Stone Bank Restaurant
DRI 674-M3

Land Use Planning Committee
Nov. 14, 2022

Applicant:	Sam Dunn
Owner:	Sam Dunn, Patrick Lyons (under purchase and sale agreement)
Proposal:	Modification of DRI 674-M to allow for a 70-seat outdoor restaurant with indoor kitchen
Permits:	Planning Board, ZBA, Wastewater Dept.
Checklist:	1.3D (Previous DRI)

RESTAURANT - COMMERCIAL UNIT C.3
 KITCHEN SPACE & SITE LAYOUT PLAN

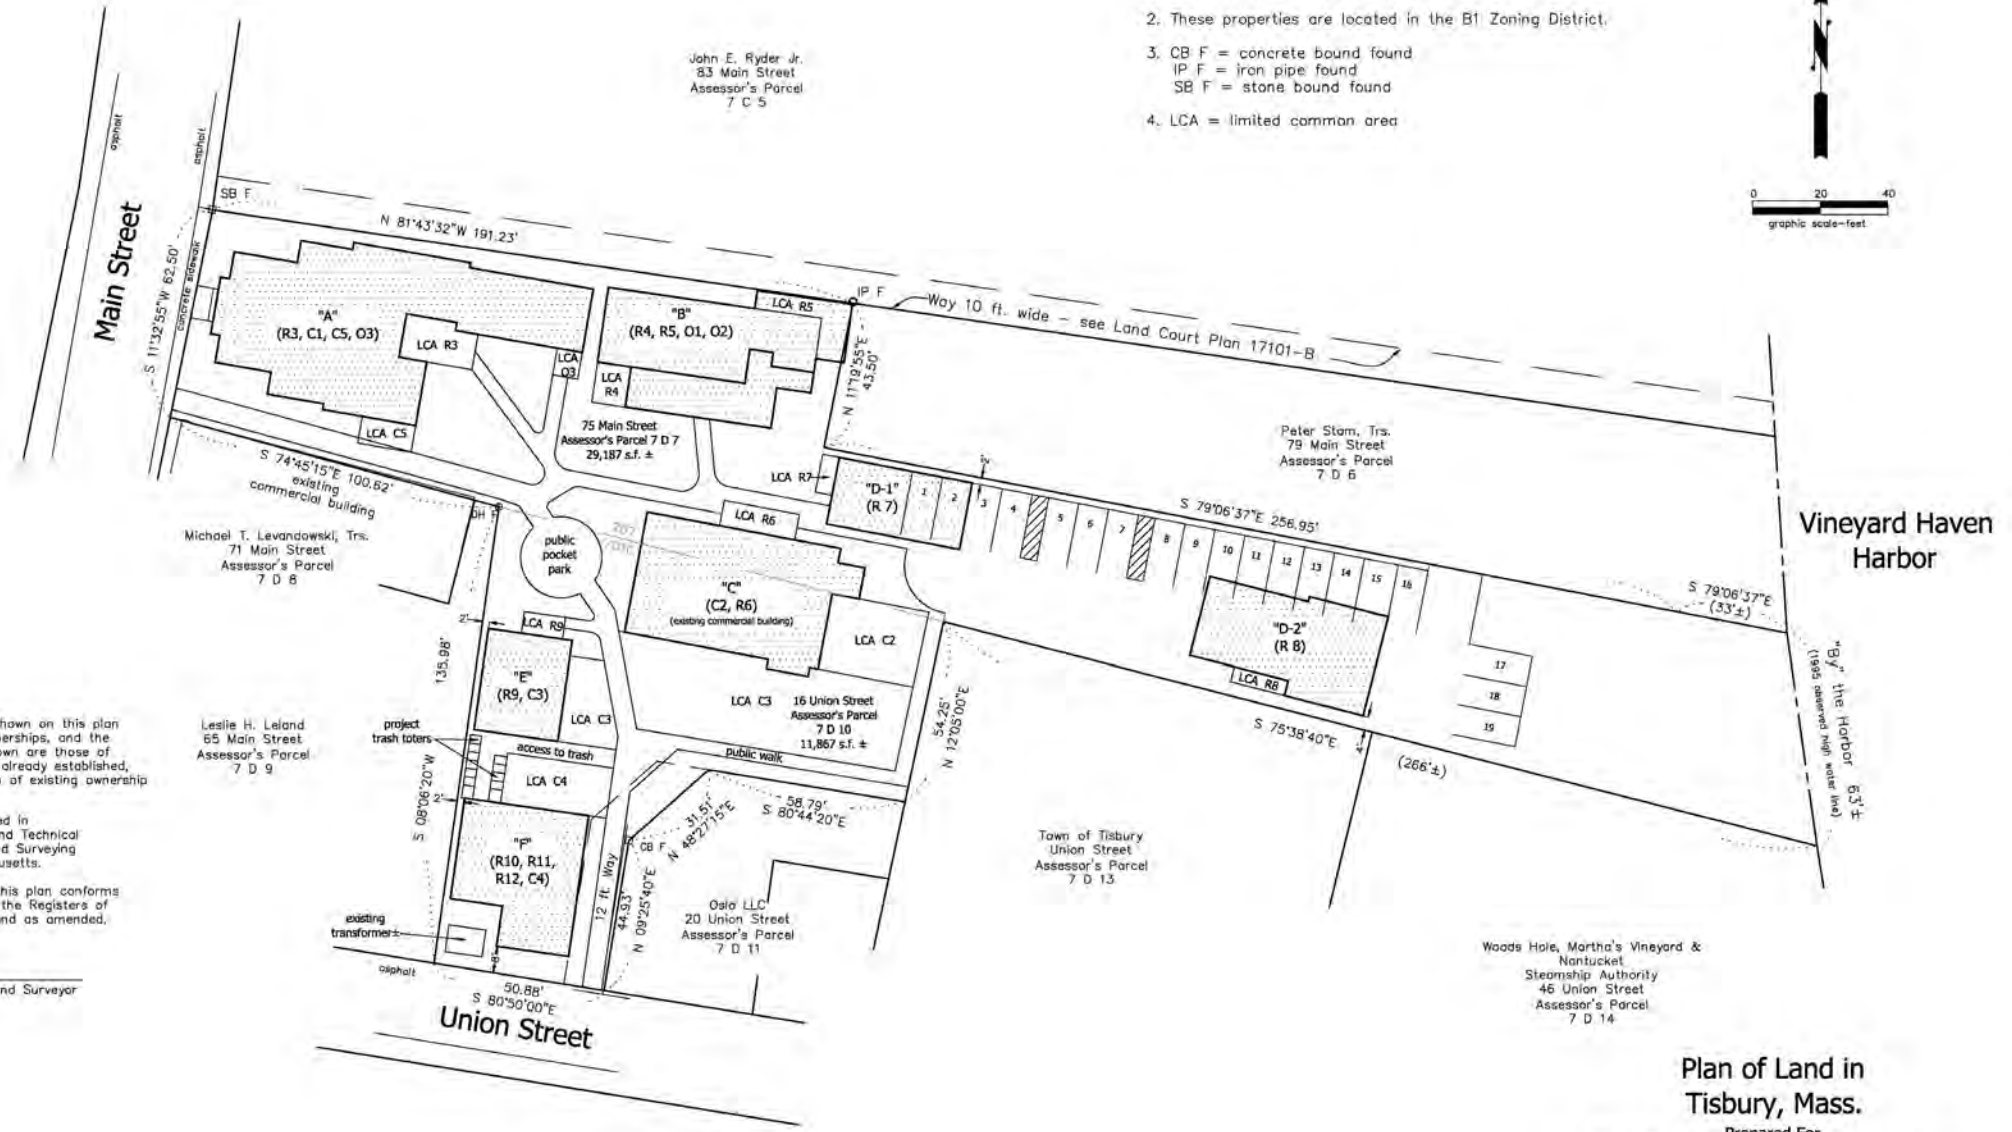
- In addition to the composting totes, six totes would be used for the restaurant’s regular waste and recycling, with two pickups per week. All of the totes would be stored in the general trash area for the condo units, which would have a capacity of 19 totes. (The eight restaurant totes would account for 42% of the trash area.)

DRAINAGE LAYOUT PLAN

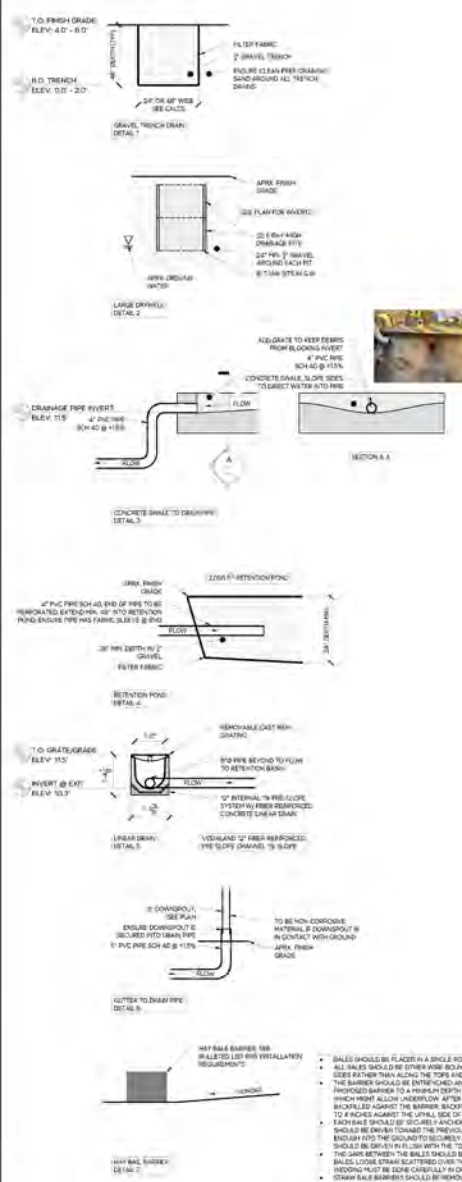
The peer review resulted in the development of an engineered [drainage layout plan](#) by MV Engineering and Design, and the following conclusions from FPES:

Given the site's underlying soil conditions we feel the design method of utilizing the naturally excellent permeability of these soils is an appropriate, and functional approach to controlling the stormwater runoff on the overall site.

We do however wish to inform the Town that if the groundwater table becomes unusually high this could diminish the effectiveness, and function of the stormwater management systems. The engineer has stated that the groundwater table is at approximately elevation 1.0. The systems designed are mostly above this elevation. The leaching pits, and drainage trenches have bottom elevations at or below this elevation. These structures will be somewhat limited due to the lower portion being constructed in the saturated soil.
